BIDDING FOR THE CONSTRUCTION OF THE TERRESTRIAL OF THE CABLE NETWORK CORRIDOR OF THE LUZON BYPASS INFRASTRUCTURE PROJECT (Segments A & B)

BID BULLETIN NO. 3

This Bid Bulletin clarifies written gueries received from prospective bidders until 5:00 PM of 9 July 2018, and other matters relative to the bidding of the aforementioned project.

PROJECT TITLE:	PREPARED BY:	APPROVED BY:	SHEET CONTENT/S:	SHEET NO.:
LUZON BYPASS INFRASTRUCTURE Terrestrial Route	ROGELIO F. ANOLIN Consultant	DENIS F. VILLORENTE Undersecretary	WARNING TAPE DETAILS	
LOCATION:	DATE SIGNED:	DATE SIGNED:	SCALE: NOT TO SCALE	TERRESTRIAL

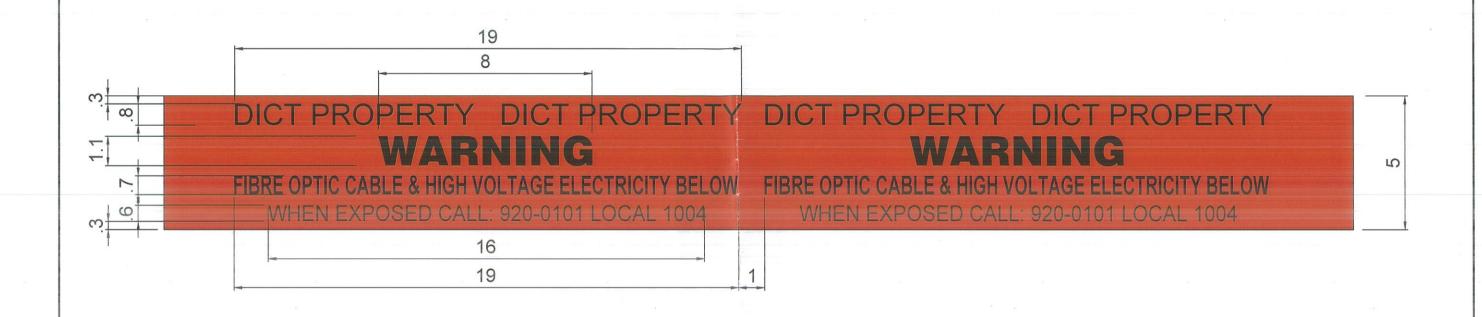
11. What are the specifications of warning tape?	Details of the warning tape is hereto attached as Annex "B" .
12. What is sump pit detail?	Minimum of 12 inches diameter and 3 inches deep.
